SUBDIVISION COMMITTEE REPORT

PROJECT NUMBER
R2014-00025-(5)

REQUESTED ENTITLEMENTS
Vesting Tentative Tract Map No. 072630
Conditional Use Permit No. 201400001
Oak Tree Permit No. 201400002
Environmental Assessment No. 201400002

MAJOR LAND DIVISION
VESTING TENTATIVE TRACT MAP
NO. 072630

SHEET 2 OF 3 SHTS

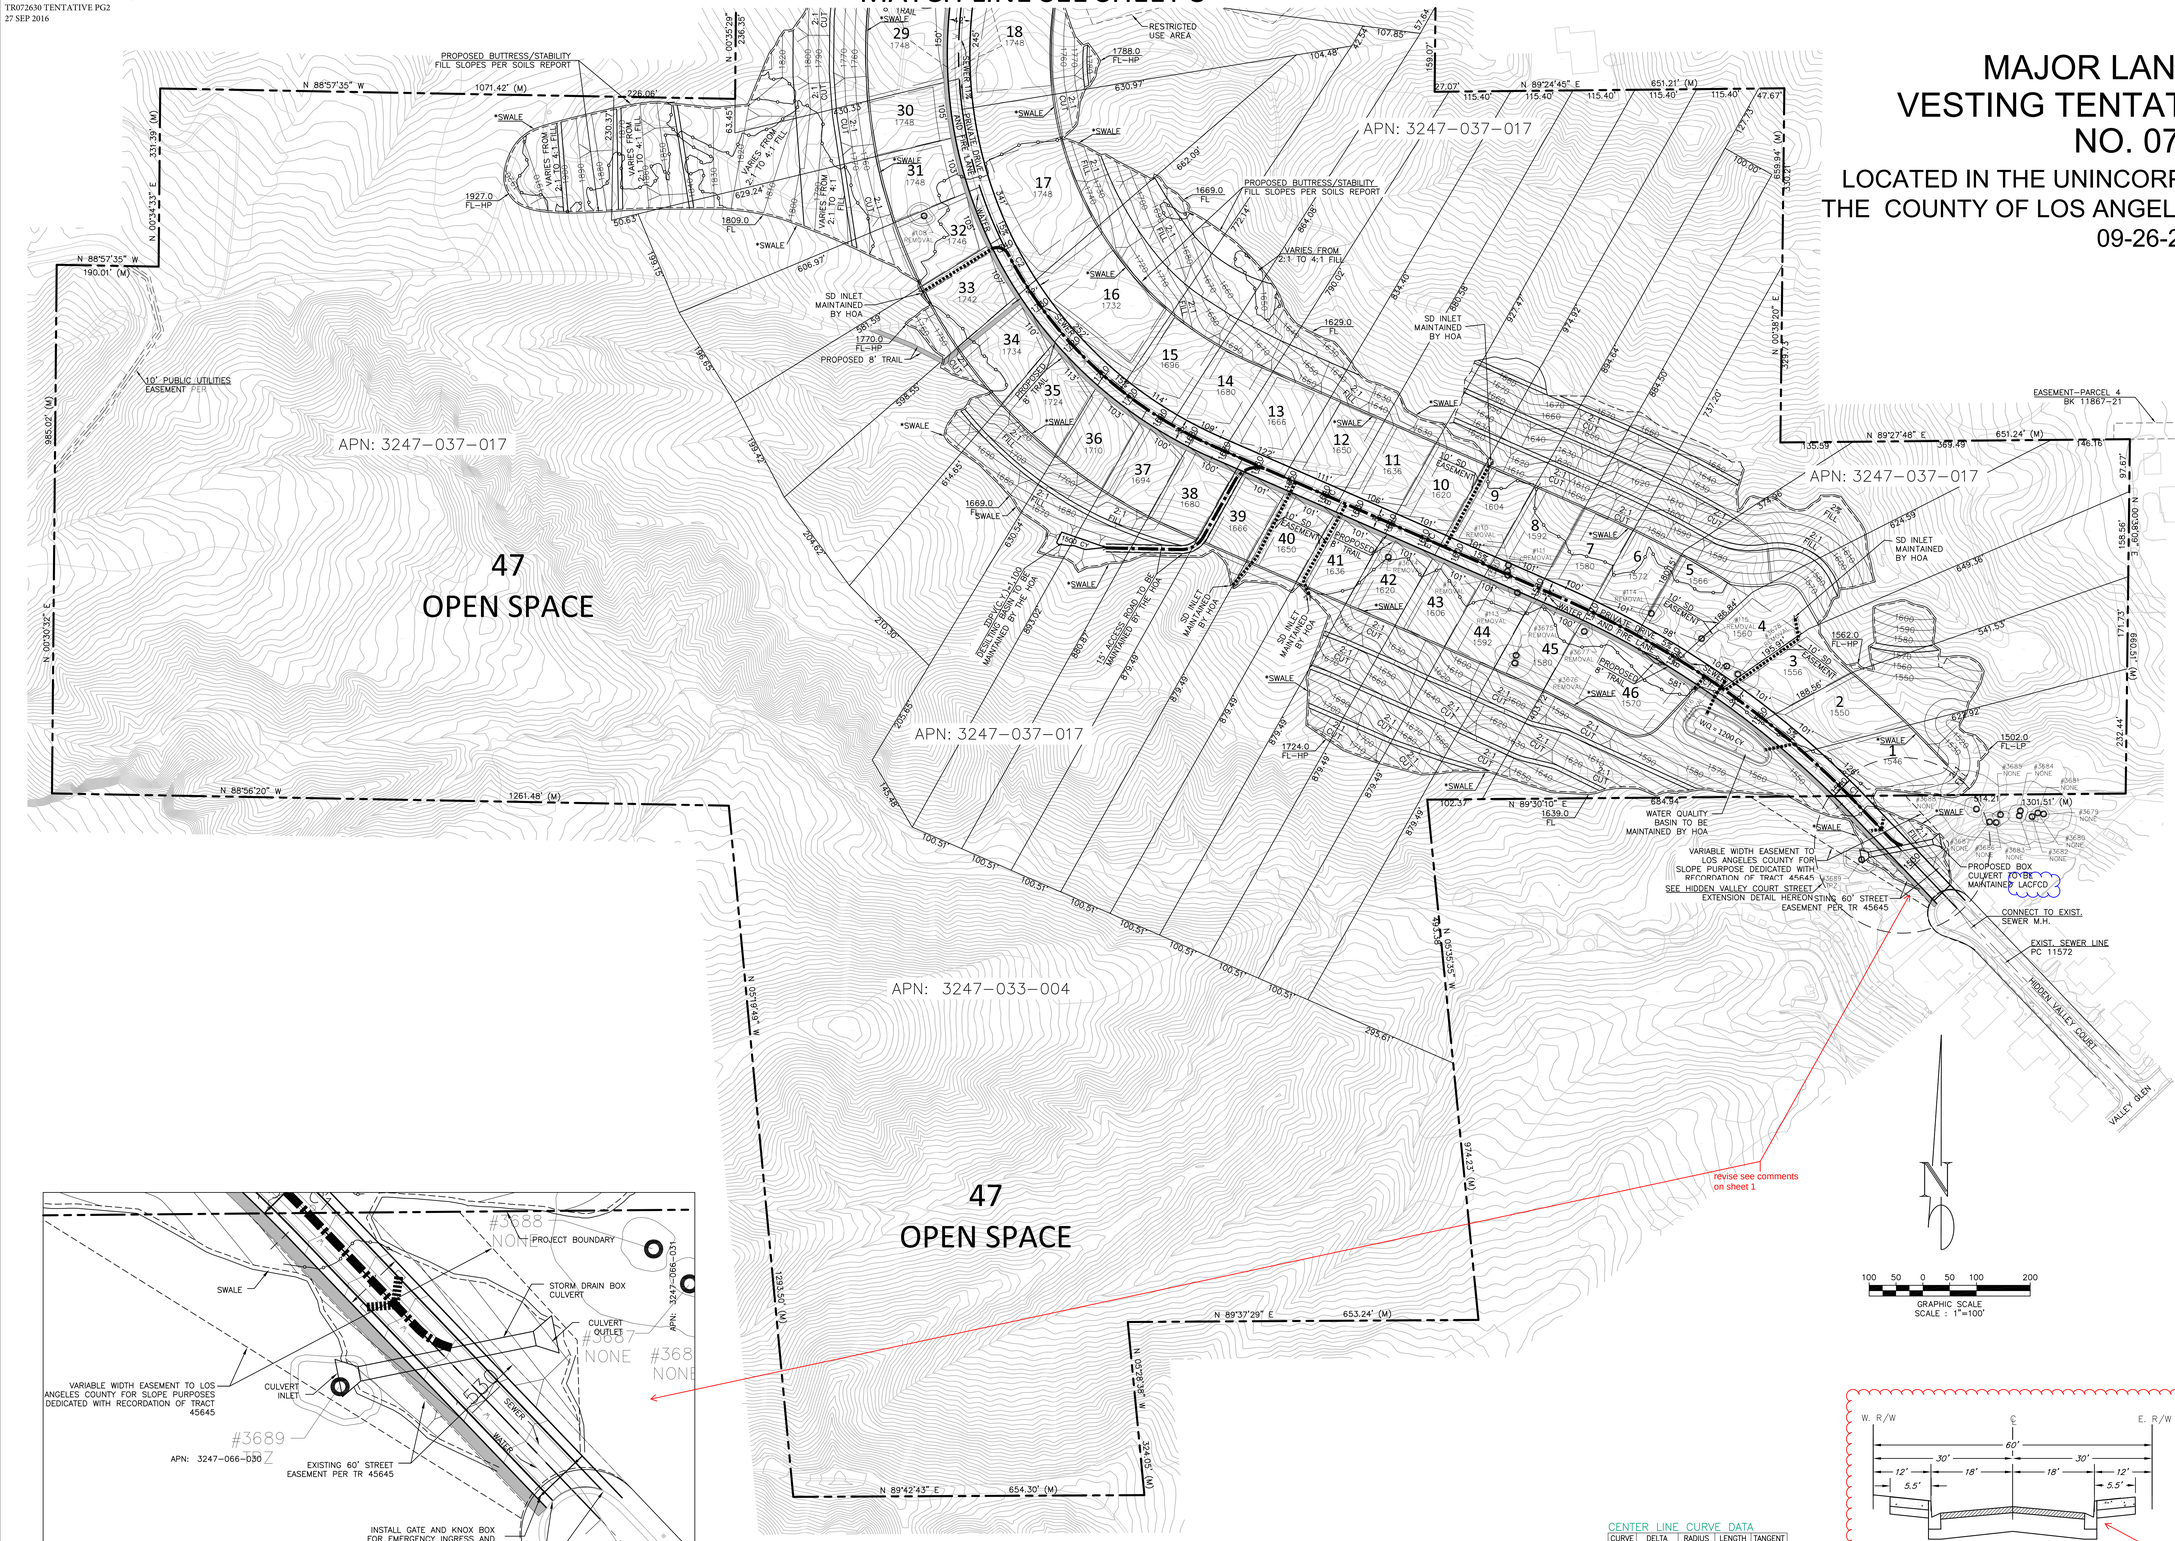
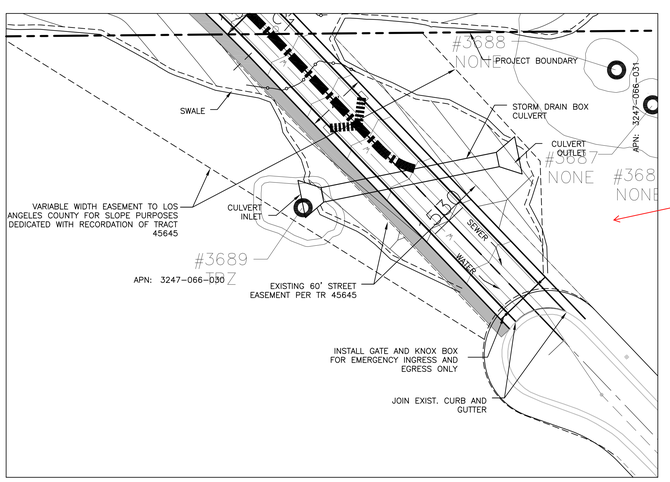
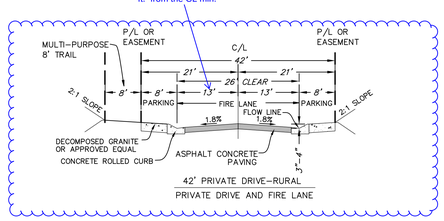
as previously requested, use standard rural section on Burlwood Drive and on Hidden Valley Court

the AC needs to be 15 ft. from the CL min.

Where is the typical section for Hidden Valley Court?
